ALERT SERVICE BULLETIN No. 081

Alternator Castellated Hex-Nut Inspection

Figure 1 - Alternator, Typical - Continental Aerospace Technologies

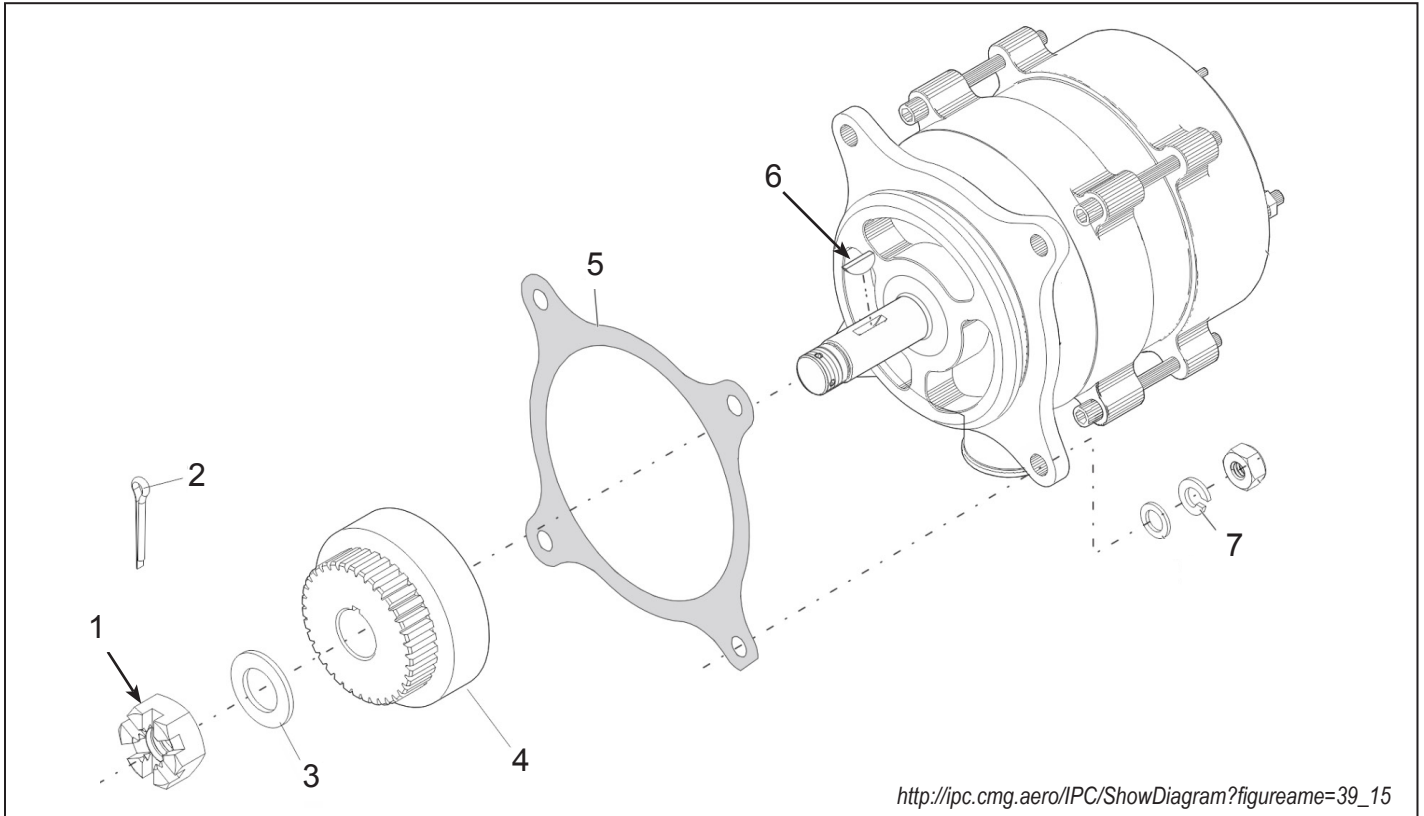
- (1) Alternators listed in section 1.A could contain a castellated hex-nut (1, Figure 1) that does not torque flush with the thrust washer (3). This condition could compromise the integrity of the drive coupling retention system.
 - (a) Loss of drive coupling retention may result in engine damage and/or unexpected loss of engine power.
- (2) This ASB is to advise the field of a known condition and to supply inspection criteria to identify affected alternators.

- (5) Remove and discard from alternator; Cotter Pin (2), Castellated Hex-Nut (1), Thrust Washer (3), and Woodruff Key (6). Refer to Figure 1.
- (6) Install new replacement components not affected by this ASB onto the alternator in accordance with applicable engine manufacturer's maintenance manual. Refer to Table 1 - *Materials Required*.

NOTE: Thrust washer (3) must be replaced per Continental Aerospace Technologies' M-0 Manual, *Standard Practice for Spark Ignited Engines*.

Figure 3 - Laser Etched "H"

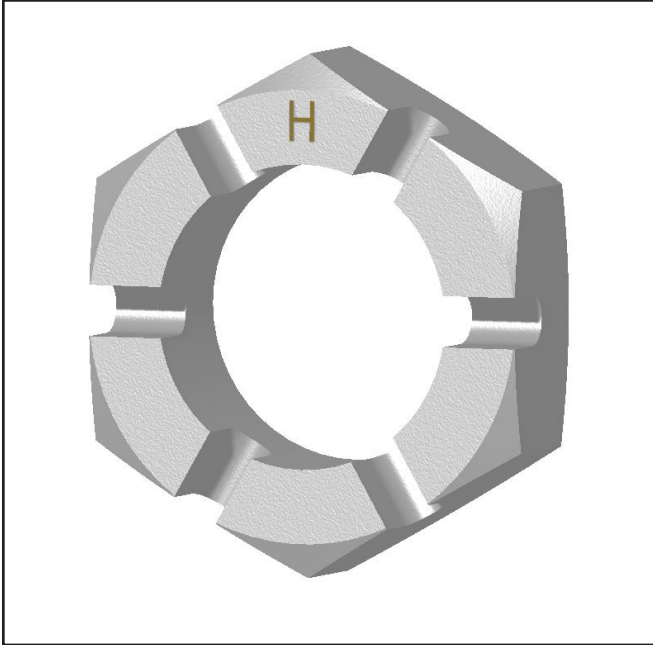
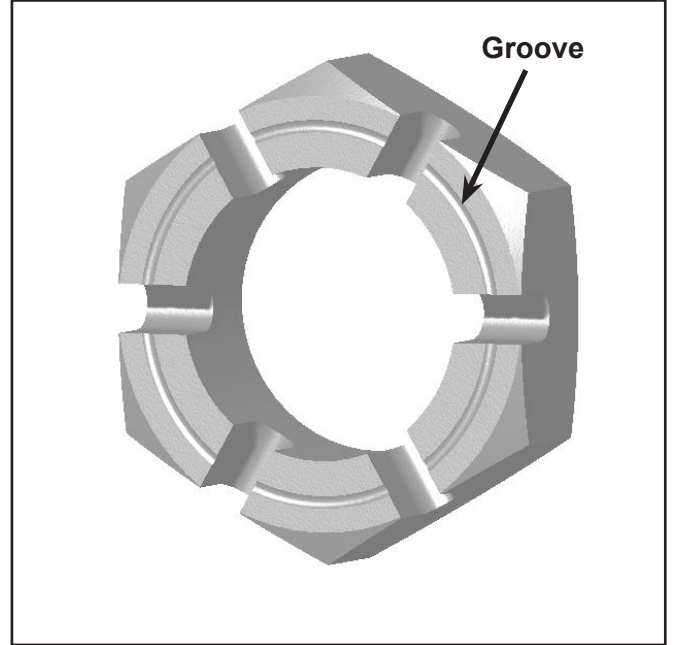
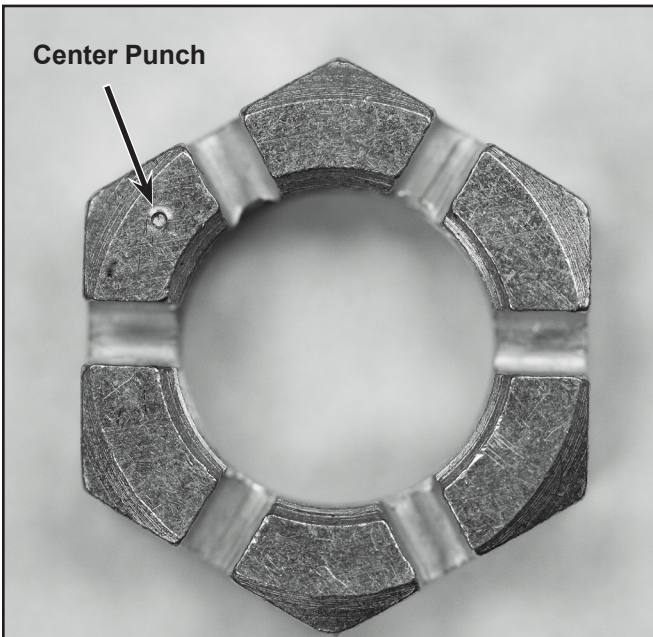
- (1) Remove the alternator from the engine in accordance with the latest revision of the aircraft and/or engine manufacturer's maintenance manual.
- (2) Inspect castellated hex-nut (1). If one the following indicators is present, the alternator is in compliance with this ASB. Refer to Figures 3 thru 5.
 - (a) Hex-nut (1) is laser etched with the letter "H";
 - (b) Hex-nut (1) is stamped with a center-punch;
 - (c) A machined groove is present around the hex-nut (1) face.
- (3) If any indicator stated above **is not** present, proceed to 3.B.(4). If one of the indicators stated above **is** present, continue to 3.B.(7).
- (4) Using a .002 in. (.0508 mm) feeler-gauge, measure the gap between the nut thrust face and the thrust washer at each of the six hex-nut flats. Refer to Figure 6.

- (a) If the measurement at any nut flat is $\geq .002$ in. (.0508 mm), continue to 3.B.(5).
- (b) If the measurement at each nut flat is $< .002$ in. (.0508 mm), no corrective action is required.
 - 1) Using an automatic center punch, punch the face of the hex-nut (1) so that it will be easily identified for future reference (Refer to Figure 5). Continue to 3.B.(7).

Figure 6 - Gap Measurement

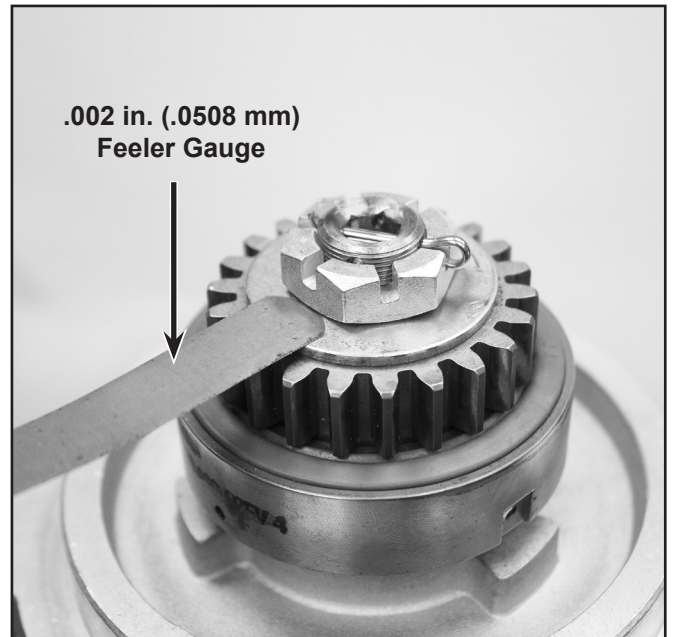
NOTE: **Do Not** remove cotter pin (2) or break torque prior to conducting measurements.
